2.2 DEFINITIONS

2.6 HYDROLOGY AND HYDRAULICS

2.6.4.4.2 Bridge Scour

Figure C2.6.4.4.2-1 – Spread Footing Location

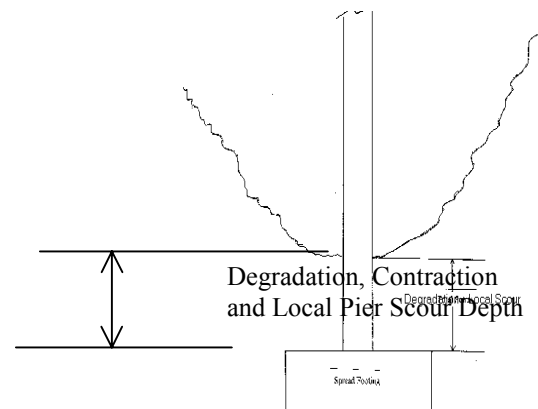
Spread footings for columns or piers on soil or erodible rock shall be located so that the ~~bottom~~ top of footing is below scour depths due to degradation, contraction, and local pier scour during determined for the a check base flood for scour.

Add Fig. C2.6.4.4.2-1 following paragraph five as follows:

Figure C2.6.4.4.2-2 – Deep Foundation Location

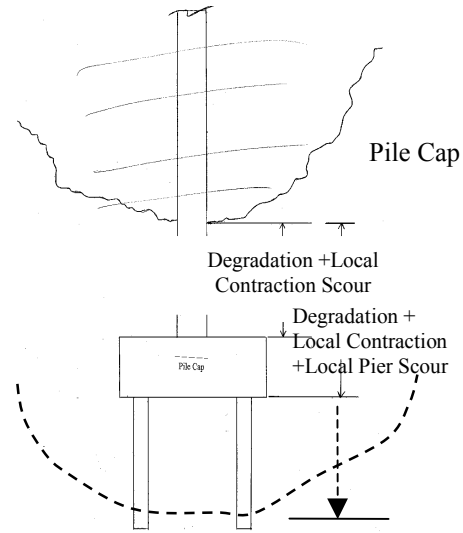
Deep foundations with footings shall be designed to place the top of the footing below the estimated degradation plus contraction scour depth where practical to minimize obstruction to flood flows and resulting local scour. The bottom of footing shall be located below the estimated total scour. However, the footing may be located above this level provided the piles and pile connections are designed to withstand this condition. ~~Even lower elevations should be considered for pile supported footings where the piles could be damaged by erosion and corrosion from exposure to stream currents. Where conditions dictate a need to construct the top of a footing to an elevation above the streambed, attention shall be given to the scour potential of the design.~~

Add Fig. C2.6.4.4.2-2 after paragraph six as follows:.
